Determination 2018/019

The code-compliance of the base of a wall to a large shed containing a dwelling at 122E Forestry Road, Waitoki, Auckland

Summary

Figure 2: Floor plan of the shed as consented (not to scale)

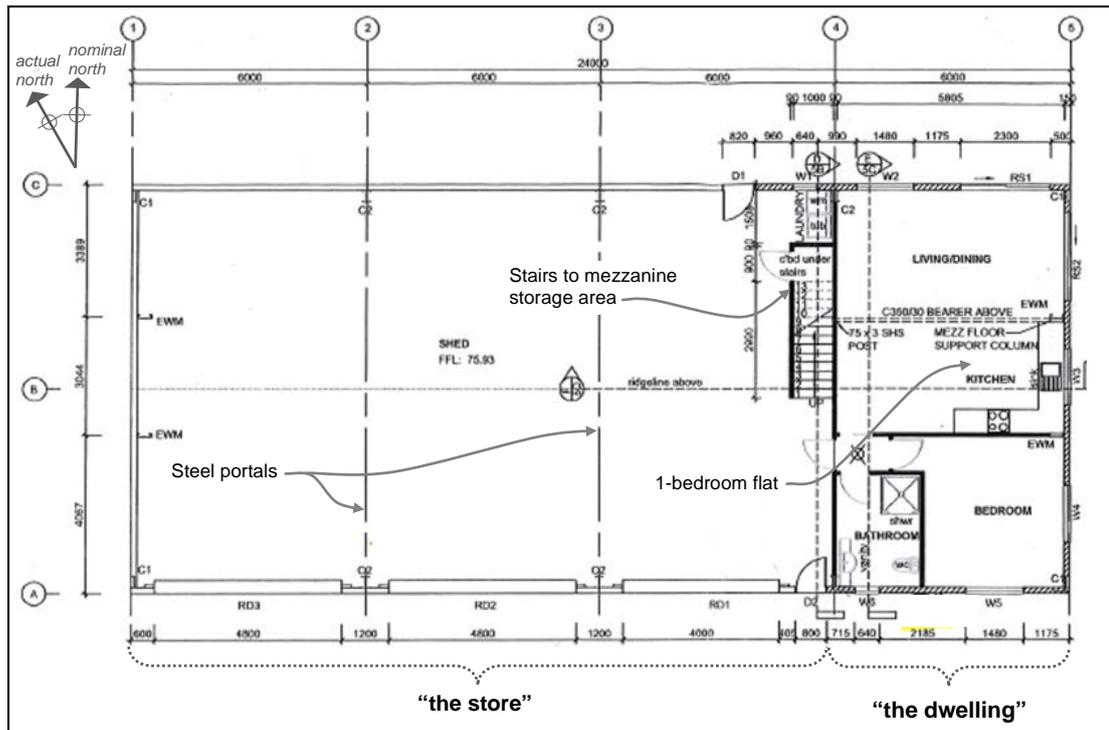
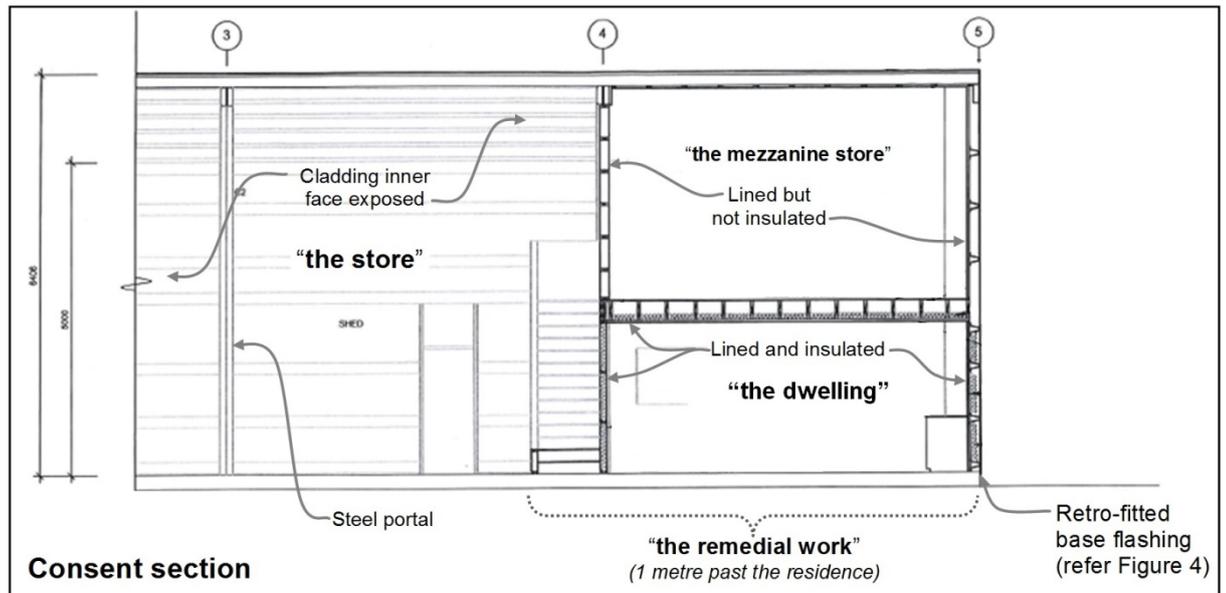
4.3.1 The minor amendment to the building consent was limited to the external walls surrounding the dwelling and 1 metre 'past [the] internal dividing wall' separating the store from the dwelling.

4.3.2 The consultant contends that the remedial detail is to be applied to the shed as a whole and the applicant's lawyer asserts that the large storage area was always intended to be lined and the entire shed is therefore 'a habitable dwelling'. The applicant says the store is to be used for the storage of household items, business records and collections, and vehicles.

- 4.3.11 The nominal 1 metre distance that the remedial detail is to continue past the portion of the shed containing the dwelling is a practical measure adopted by the authority. Any water entering under the cladding will have a limited effect on adjacent building

- 4.3.12 However, the lined walls encroach into the store and in my view the 1 metre distance applies equally to the lined area of the walls in the store because the lining is a building element that would be damaged by water entering under the cladding. Therefore, the remedial detail should be applied to the areas of the store where the walls have been lined. I note the lined walls terminate at the personnel doors and the width of the doors, in effect, provide the 1 metre separation at that point.

- 4.3.14 In my opinion, the shed with the remedial work limited to the part of the building containing the dwelling and to those areas of the store where the external walls are lined, with the addition of a satisfactory detail at the junction of the lined wall and personnel doors, means the building as a whole will satisfy the minimum requirements of Clause E2 External moisture.

Figure 4: The approved remedial base flashing detail (not to scale)

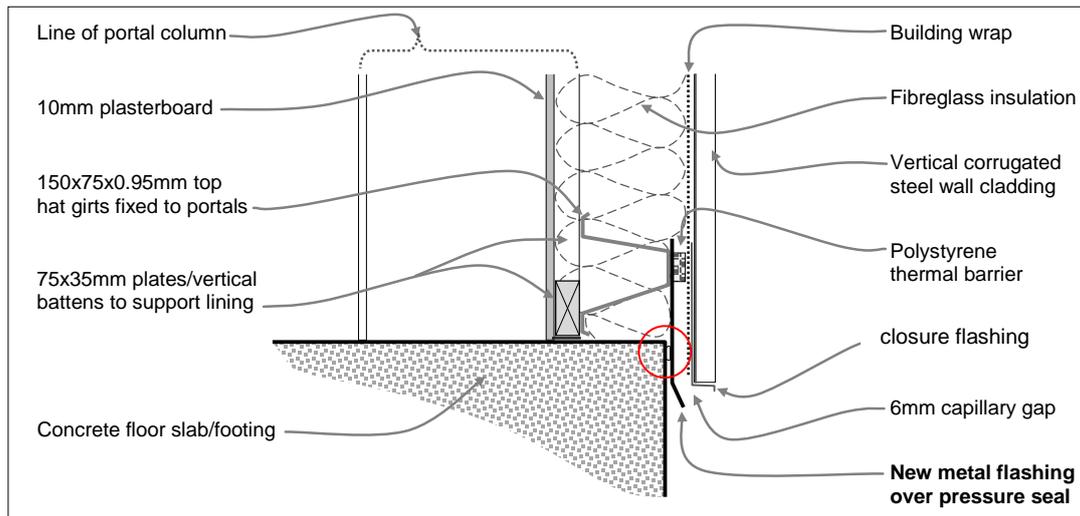
- 2.3.2 The hand-drawn detail of the additional flashing on drawing 19/9 (shown in Figure 4 as “new metal flashing over pressure seal”) is stamped as approved by the authority on 6 November 2017 and has the title (emphasis added):

- 2.3.3 The new metal flashing (“the base flashing”) was designed to provide a 6mm capillary gap between the base flashing and the existing closure flashing.

4.2.3 I consider the detail referred to by the parties contained in E2/AS1 (Figure 93) has a limited application to this situation (refer Appendix A.4). Figure 93 only addresses the likelihood of capillary action drawing water up between the concrete slab and the rear of the cladding to the bottom plate. The bottom plate and closure flashing in Figure 93 is, in effect, providing a sealed air path above the top of the slab.

4.2.4 In the subject building, moisture-laden air is able to be drawn up under the base of the cladding and onto the concrete slab. There is no form of pressure equalisation to help prevent moisture-laden air being drawn into the building. While there has been an emphasis on avoiding the effects of capillary action, I do not consider this is the principle means by which water will enter the cladding at this point.

- The gap between the base flashing and the closure flashing is reduced at the base of these two flashings: the thermal barrier will in effect form an air seal between both flashings. The gap between the two flashings itself would not have given any rise to capillary action.

- The base flashing extends some 80mm below the concrete slab. The bottom kickout to the base flashing minimizes capillary rise behind the flashing.
- The closed-cell foam seal behind the base flashing will reduce air and moisture movement into the wall space. The closed-cell foam itself will not allow the passage of water, i.e., water will not be drawn through the foam.

- However, the foam is only 3mm thick. This may not be thick enough to allow for construction tolerances in the relative location of the bottom girt and the edge of the concrete slab, and for variations in the slab edge itself. The proximity of the base flashing to floor slab along the length of the slab needs to be verified on site.

4.2.6 In principle, the remedial base detail will provide a solution that will meet the performance requirements of Clause E2. However, the location of the base flashing relative to the edge of the concrete slab should be verified onsite to confirm the effectiveness of the foam seal. The assessment might be done by carefully probing this junction at sample points to test for any gap.

- 5.1 In accordance with section 188 of the Building Act 2004, I hereby determine the remedial base detail as described in paragraph 2.3 of this determination, pending verification as set out in paragraph 4.2.6, means the building as a whole will comply with Building Code Clause E2 External moisture.
